# SAN FRANCISCO PLANNING DEPARTMENT

## Memo to the Planning Commission

*Date:* July 29, 2010  
*Case No.:* 2010.0236 DDD  
*Project Address:* 71 CUVIER STREET  
*Permit Application:* 2009.10.15.9021  
*Zoning:* RH-1 (Residential, House Districts, One-Family)  
40-X Height and Bulk District  
*Block/Lot:* 6722/018  
*Project Sponsor:* Emily Huang  
1736 Stockton Street  
San Francisco, CA 94133  
*Staff Contact:* Corey Teague – (415) 575-9081  
[corey.teague@sfgov.org](mailto:corey.teague@sfgov.org)

## Discretionary Review Analysis

3/15/10  
8:00AM

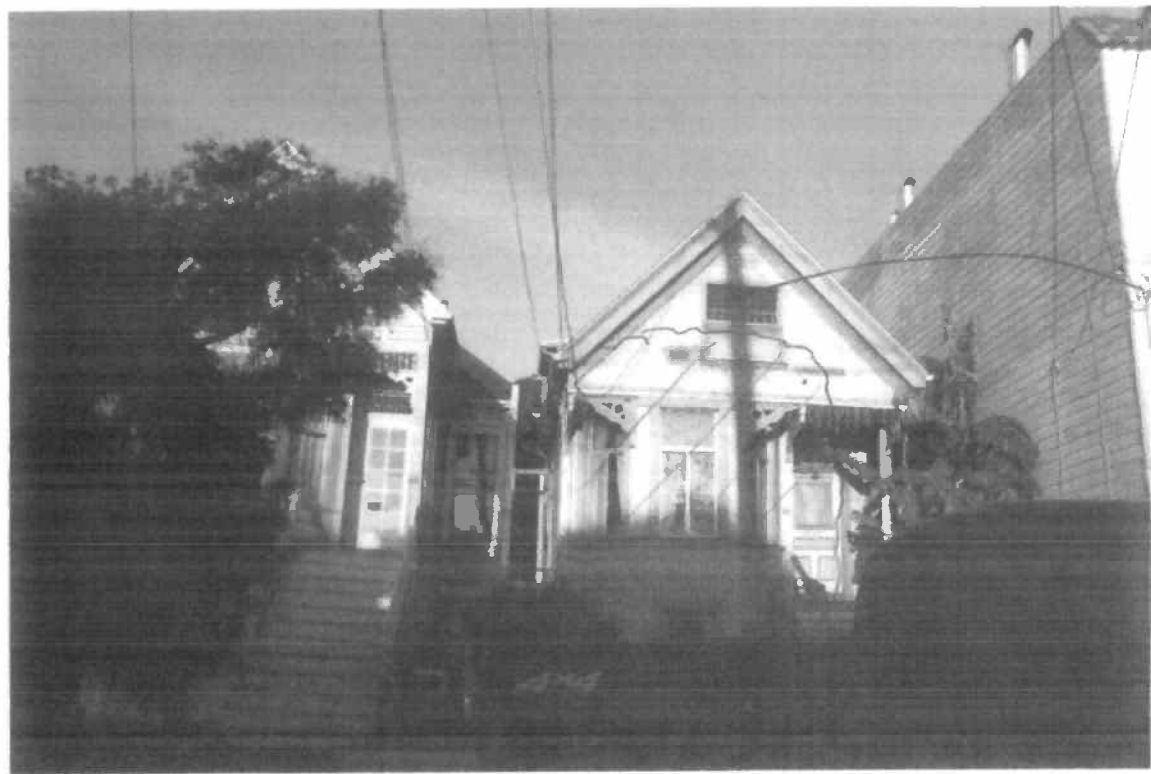
SHADOW OF  
P&E POLE  
LOCATED @  
71 CUVIER  
LOSS OF  
DIRECT SUN  
LIGHT

SLASH  
MARK INDICATE  
LOSS OF DIRECT  
SUN LIGHT

3/15/10  
8:00AM

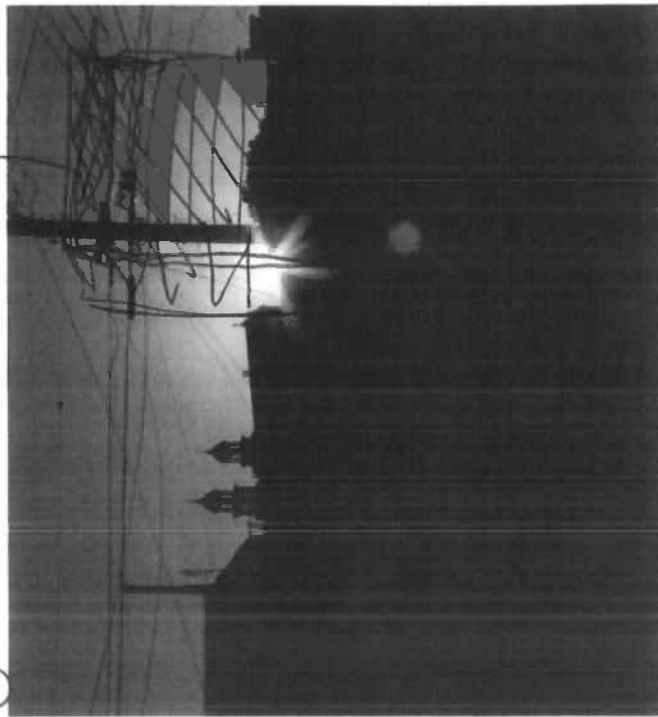
SHADOW OF  
P&E POLE  
LOCATED @  
71 CUVIER  
LOSS OF  
DIRECT SUN  
LIGHT

SLASH  
MARK INDICATE  
LOSS OF DIRECT  
SUN LIGHT

① Sunrising @ location of Proposed building @ 71 Cuvier

TPER Currier St. - Same Block as proposed development @ 71 Currier St

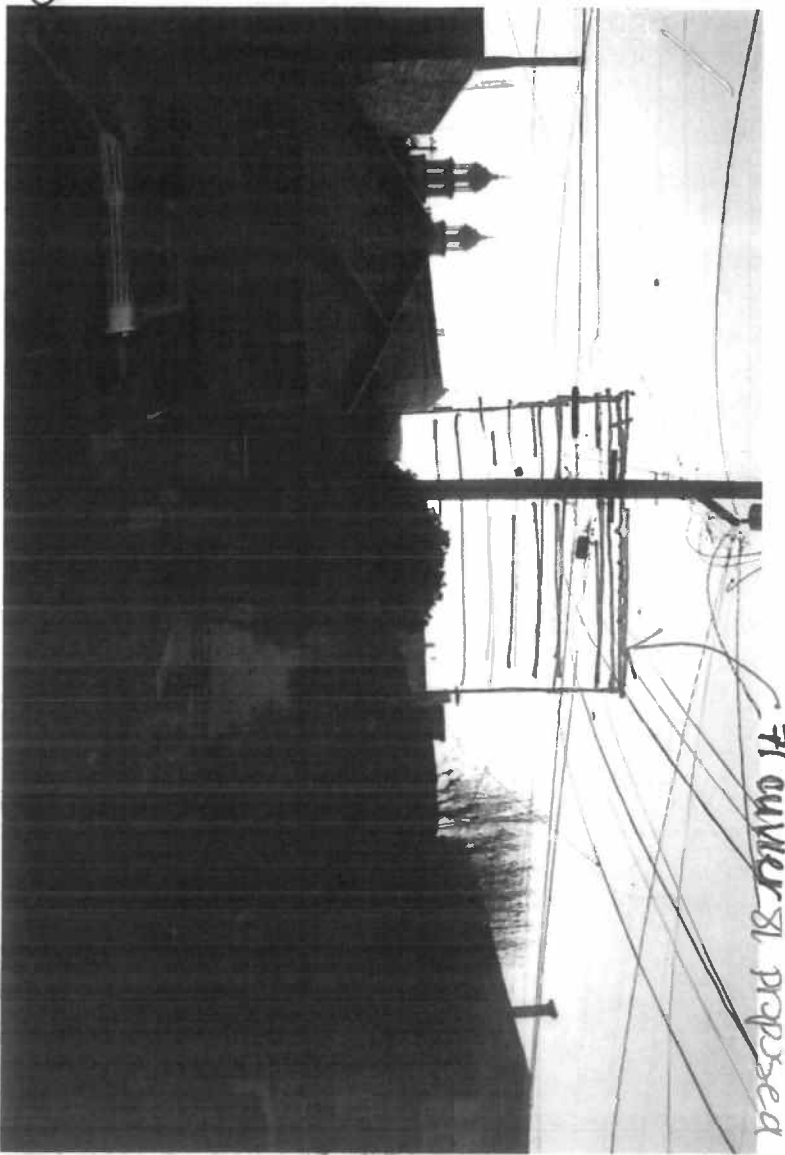
houses Grouped and complement each other in height.

1/2 Sun Rise @ 26 Currier  
Looking over 71 Currier St

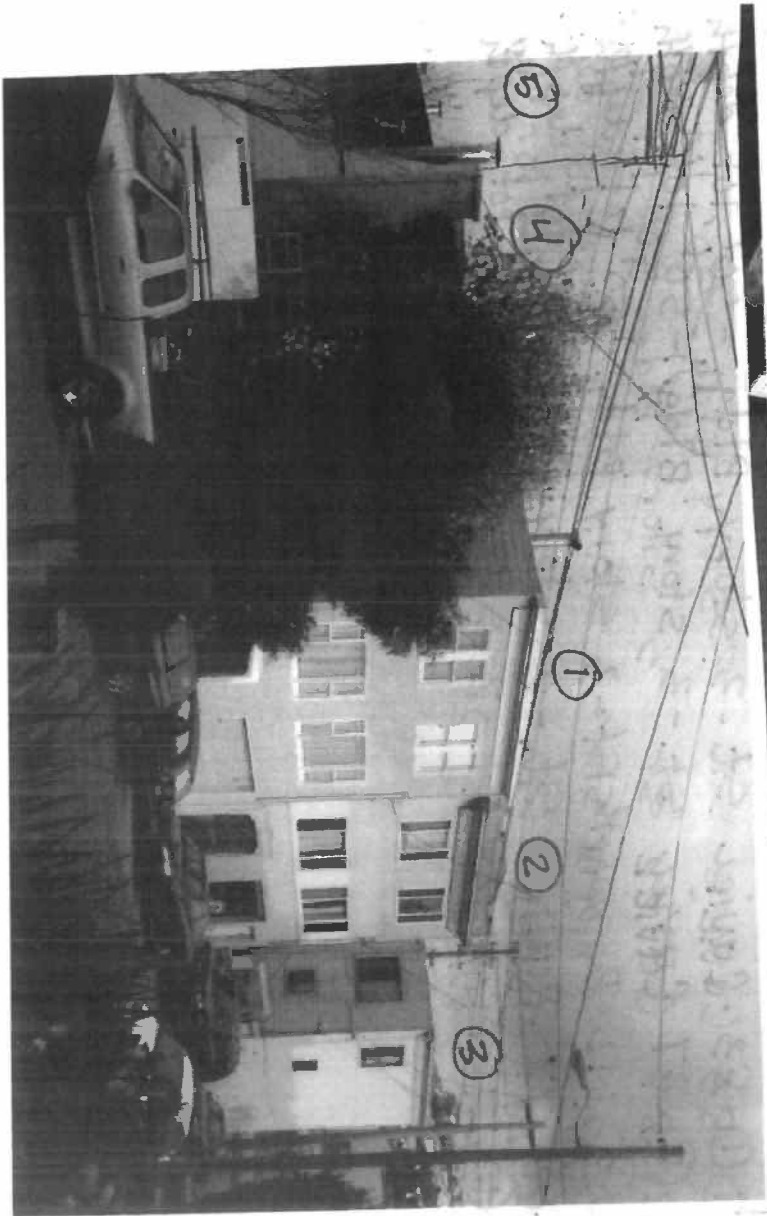
3/4 Sunlight on facade of 26 Currier  
Looking from 71 Currier St

Item B #2- 26 Cuvier Street grossly shadowed, 28 Cuvier Street shadowed- We performed a sun and shadow study with the old house and new house for 12 months of the year at 7am, 8am, and 9am. The results show that the impact at 7am is not significantly different between the old house and new house all year round. At 8am, the new house does shadow 26 Cuvier for March, April, September and October more than the old house. At 9am, the new house does not cast shadows on 26 or 28 Cuvier Street - please see attached sun/shadow studies.

18 Mersily Backyard facing West

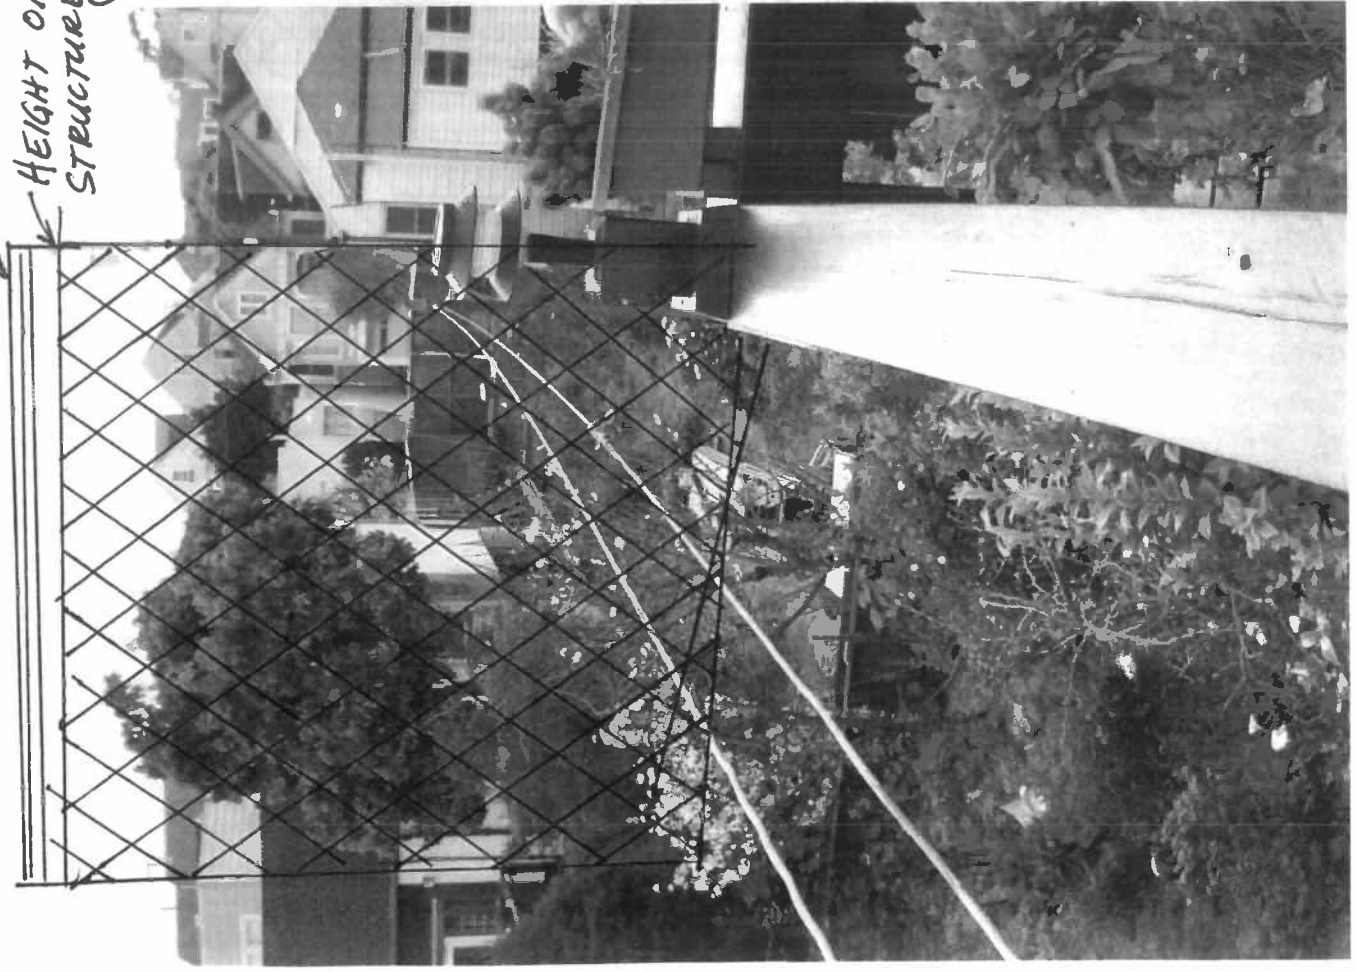
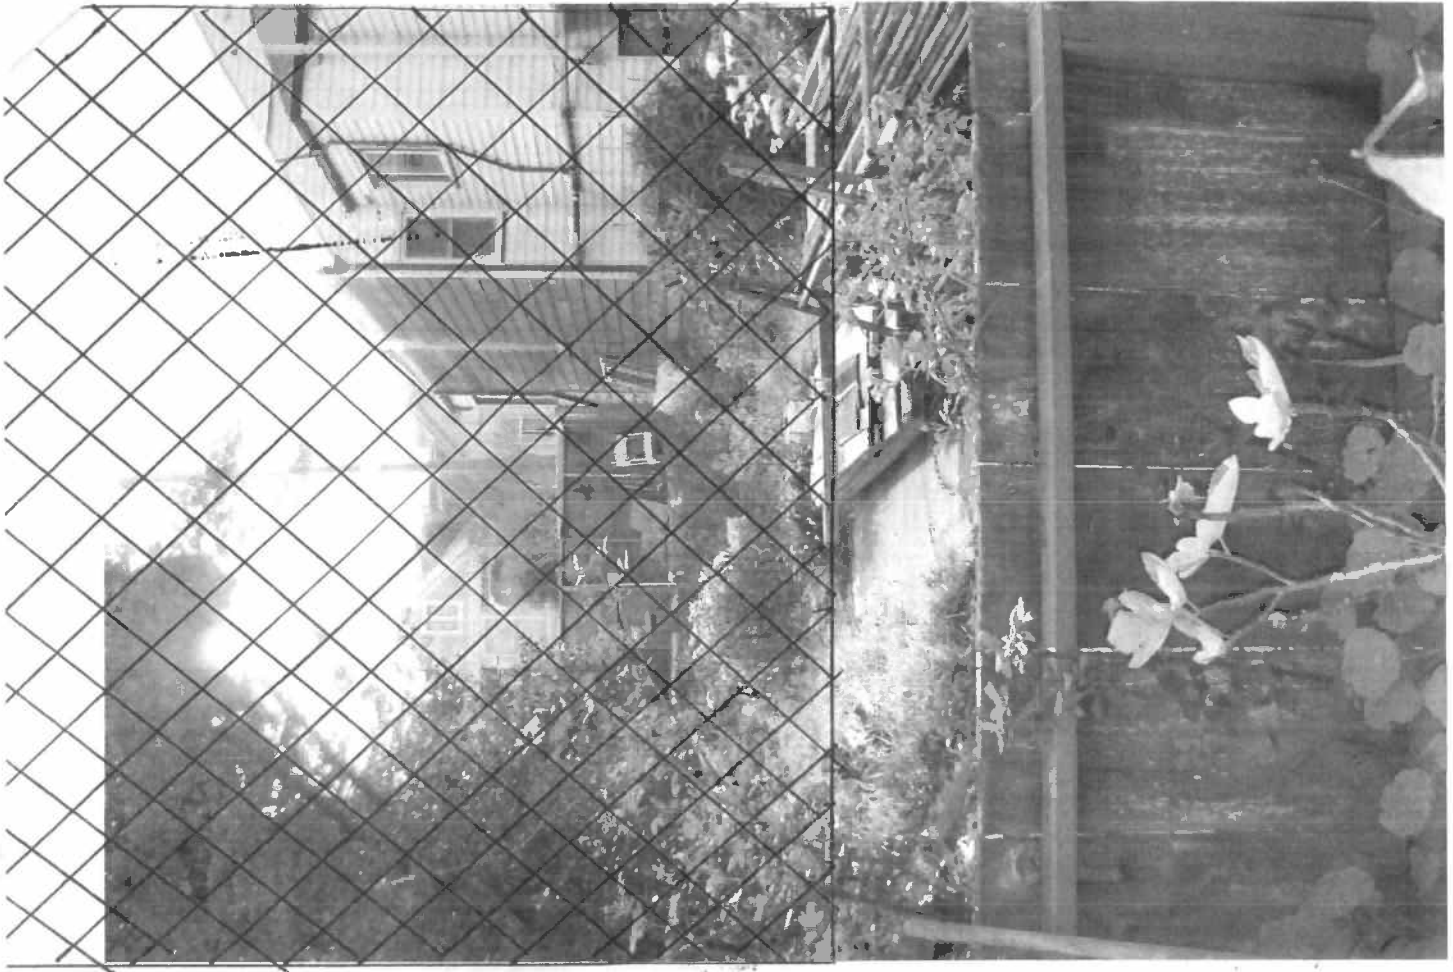
HEIGHT OF  
STRUCTURE

HASH MARKS SHOW PROPOSED STRUCTURE AT 71 CUYER RD 236D  
Photo taken from rear yard of 18 MARSHY ST.

Photo taken from  
18 Mausily St. rear dec

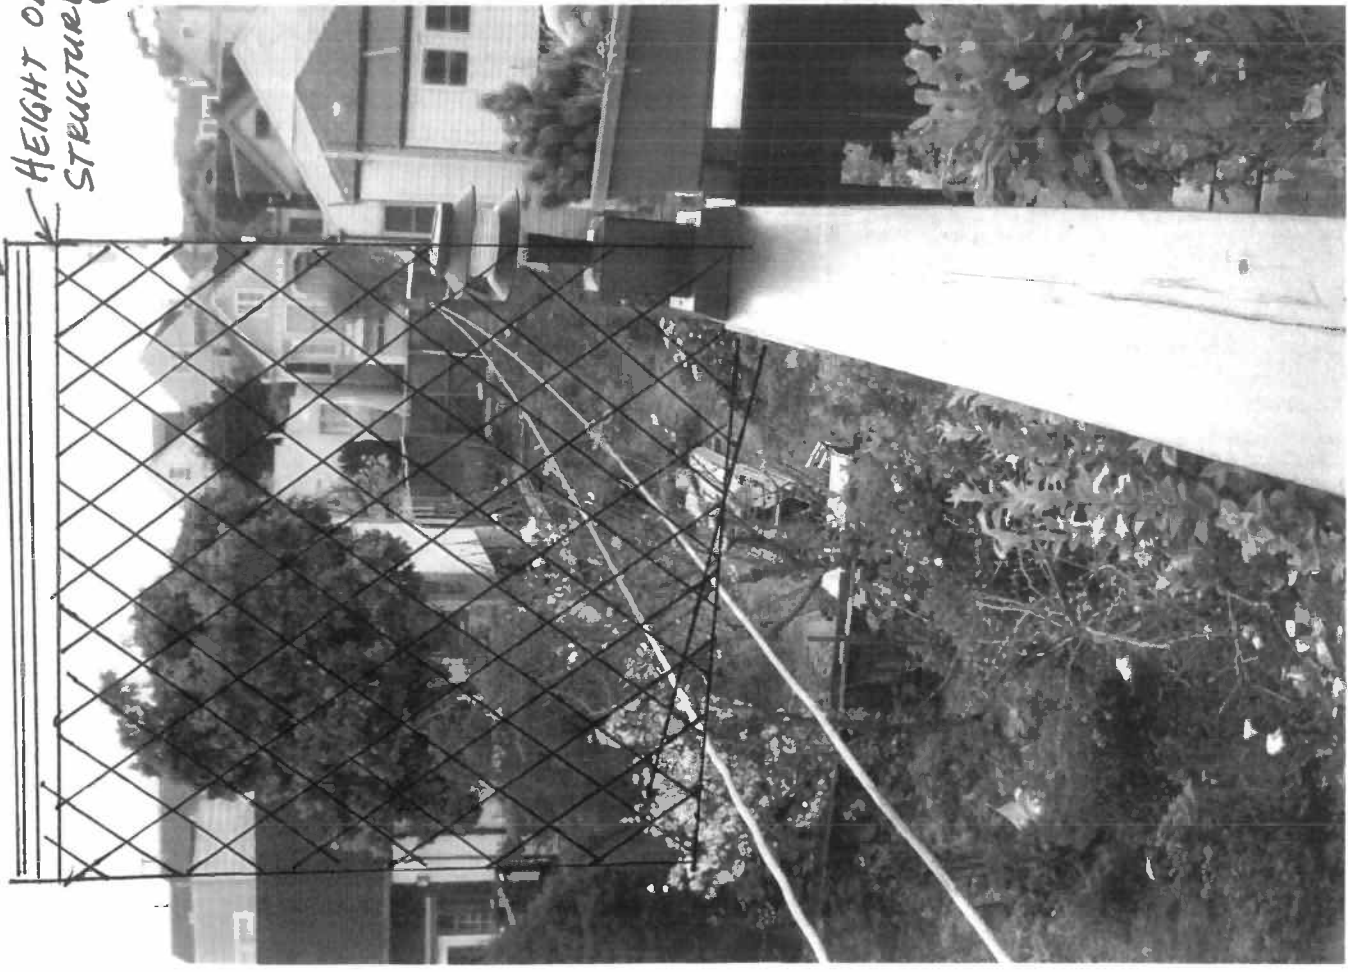
HEIGHT OF PARAPET  
HEIGHT OF PROPOSED  
STRUCTURE @ 71 CURVED

SITE PLAN- FOOT PRINT OF OLD HOUSE

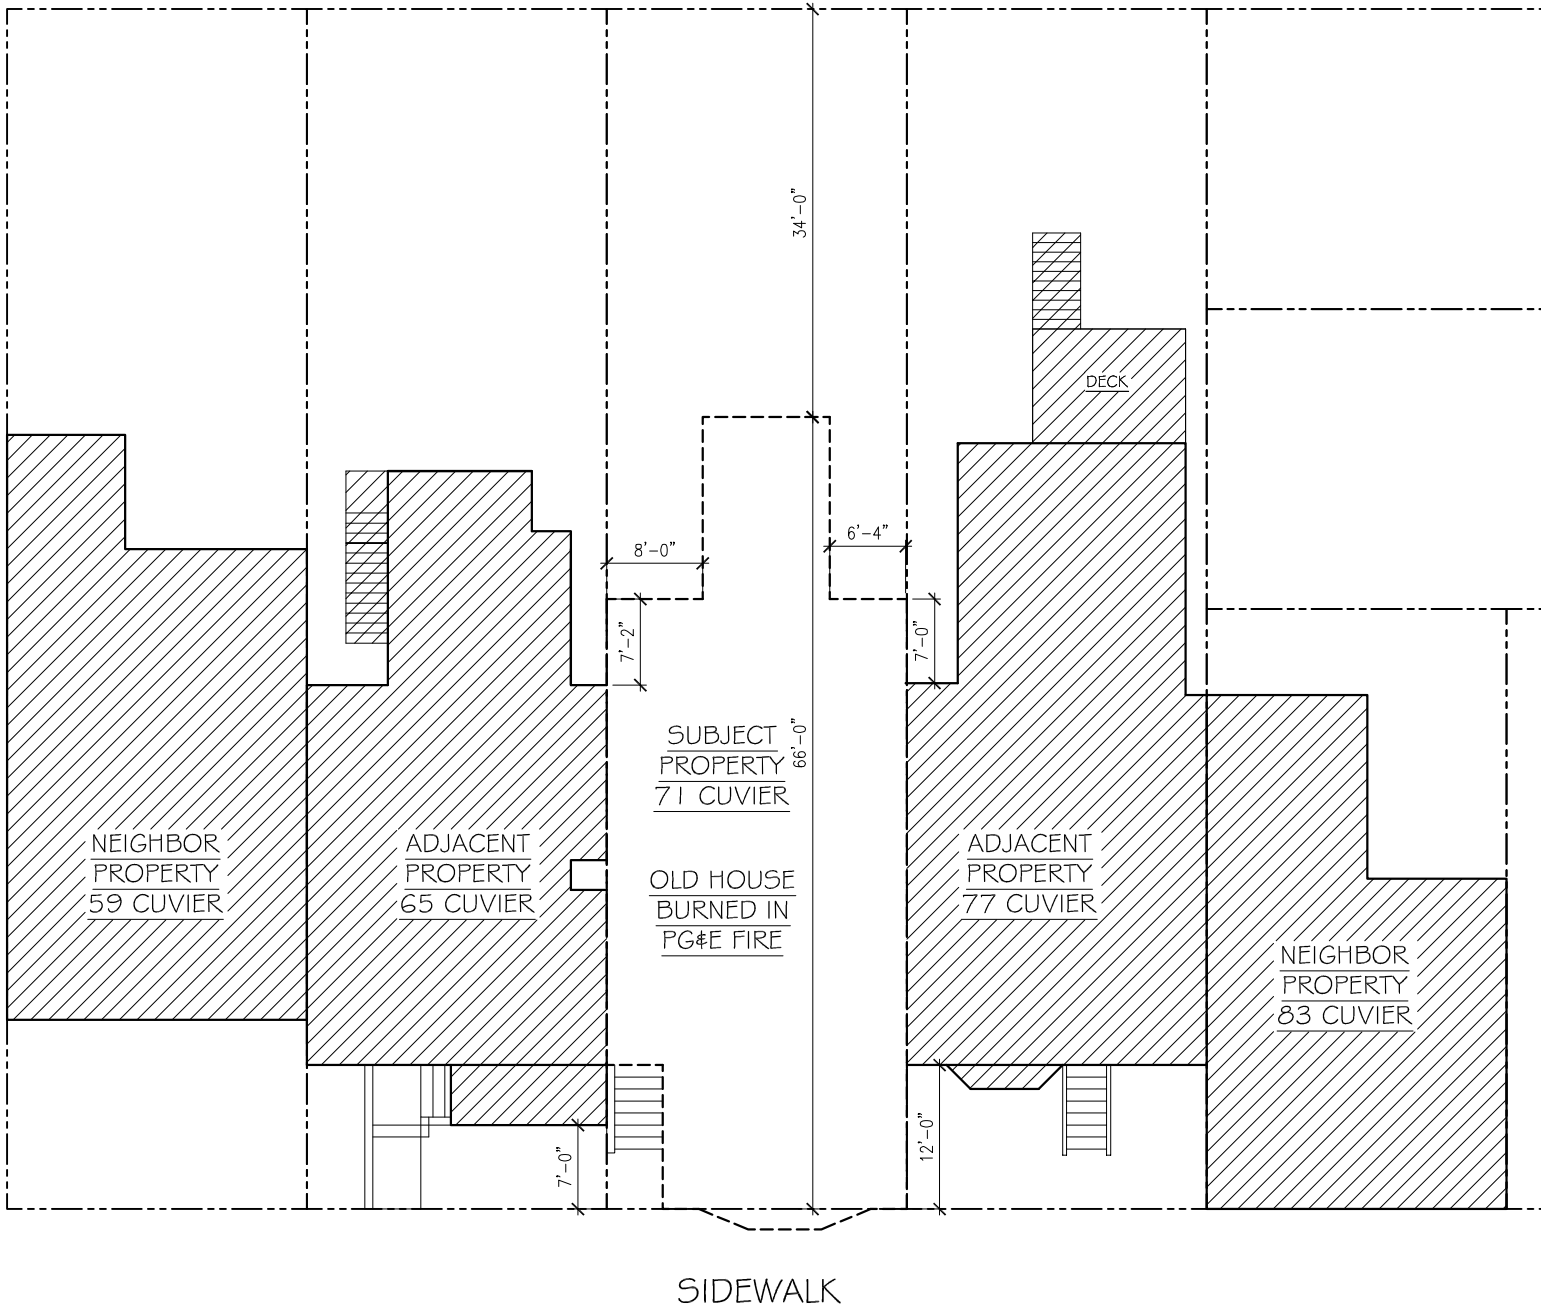
Item B #3- Adhere to the footprint of the original (1908) house, reduce ceiling height, and setback house for avocado tree- Adhering to the footprint of the demolished 1908 house is not feasible for the following reasons: 1) The old house that was destroyed in the fire did not have a front yard setback. It was 66' in length. If we adhered to the footprint of the original house and the new house has to observe a front yard set back of 9'-6" per SF Planning code, the resulting design would make the rear yard less than 25'-0" in length. A minimum rear yard would not be preferable to the project sponsors, the Planning Department or the DR requestors. 2) If the front set back code is waived in this case by the Planning Department, the solution would aggravate DR requestor #1's concerns of shadow cast across the street. The new house would violate the established pattern of setbacks and street frontage created by the neighboring houses on the block. 3) The layout of the 1908 house was designed for the uses of a family more than 100 years ago. The project sponsors would like to build a house that is designed to today's living standards and can accommodate their growing family of 5 plus visiting friends and family. The footprint of the new house is well within the requirements and guidelines of all planning codes and regulations. 4) The foot print of the new house is 1448 sf while the foot print of the old house was 1411 sf. The foot print of the new house is 37 sf larger than the footprint of the old

Item B #3- Building shortened in length back to original house and reduction in building height- The old house that was destroyed in the fire was 66' in length. It did not have a front yard setback and therefore the old rear yard was 34 feet deep. The new house has to observe a front yard set back of 9'-6" per SF Planning code and is 60'-0 1/2" in length. Therefore the new rear yard is 30'-5 1/2" deep and 3'-6 1/2" lesser in length than the old rear yard while the new front yard is 9'-6" deep. The new house has been reduced in length by 5'-11 1/2" from the old house. The new house has a 4'-0" x 13'-1 1/2" setback on the ground floor (first floor) making the rear yard 34'-5 1/2" deep for half the width of the lot at the ground floor.
